SUBJECT: Forwards marked-up pages from FSAR section 17.2 re plant QA program, to support NRC review of changes originally proposed in licensee 970818 submittal. Changes do not include other changes permitted to be made by util. under 10CFR50.54(a).

**SUSQUEHANNA STEAM ELECTRIC STATION
SUBMITTAL OF MARKED-UP FSAR PAGES
QUALITY ASSURANCE PROGRAM CHANGES
PLA-4900**

**SUMMARY OF CHANGES TO FSAR QA PROGRAM DESCRIPTION:
CHANGE TO NUCLEAR ASSURANCE ORGANIZATION AND QUALIFICATION
REQUIREMENTS FOR MANAGER - NUCLEAR ASSURANCE**

QA Program Changes Described in PLA-4662

FSAR FIGURE 17.2-3

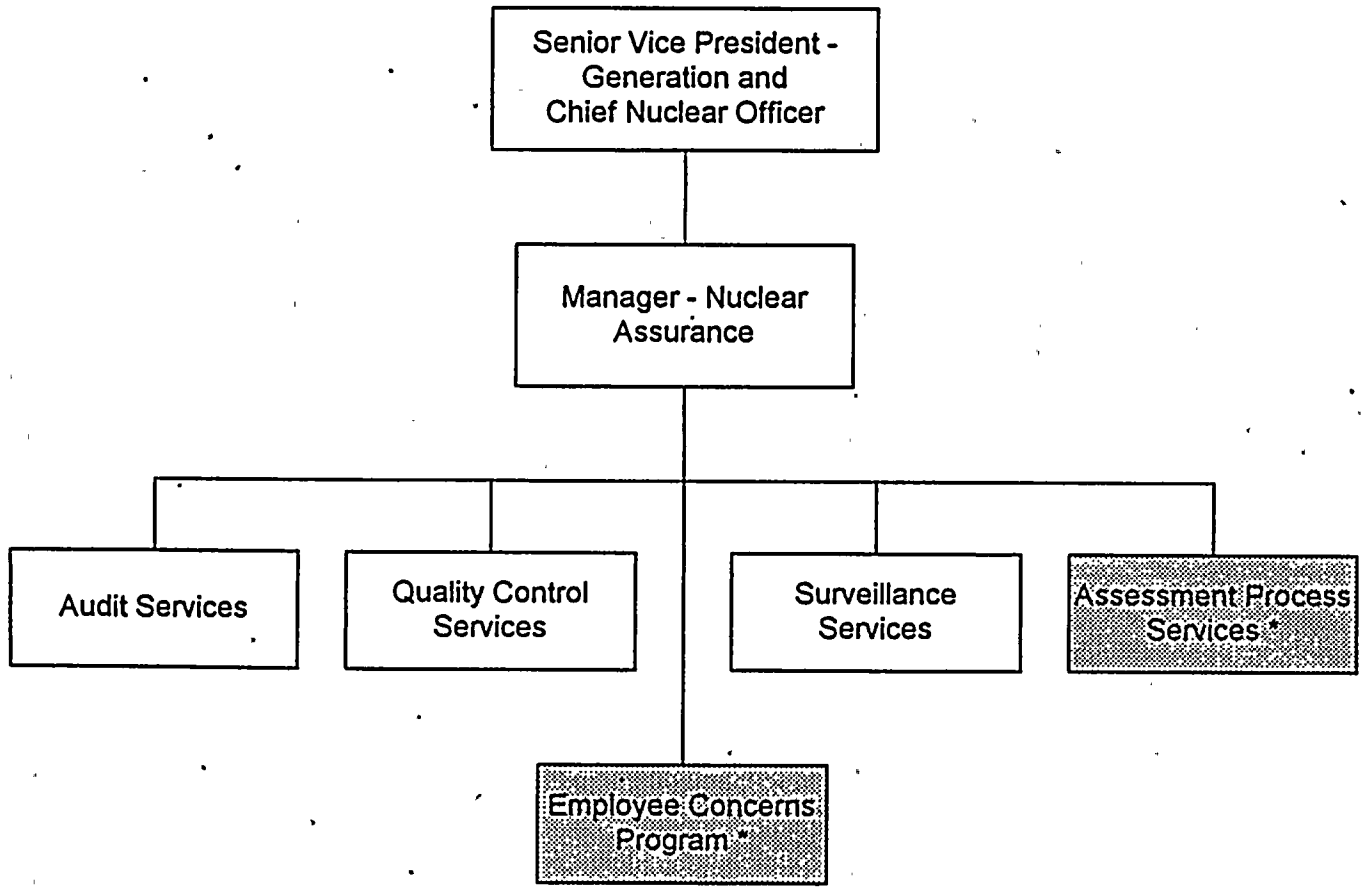
Nuclear Assurance
To fulfill the organizational responsibilities, NAS is structured as functional groups. Figure 17.2-3 diagrams the reporting relationships of these groups and their functional responsibilities are described below:

*insert revised
Figure 17.2-3
attached*

Figure 17.2-3 (Revised)
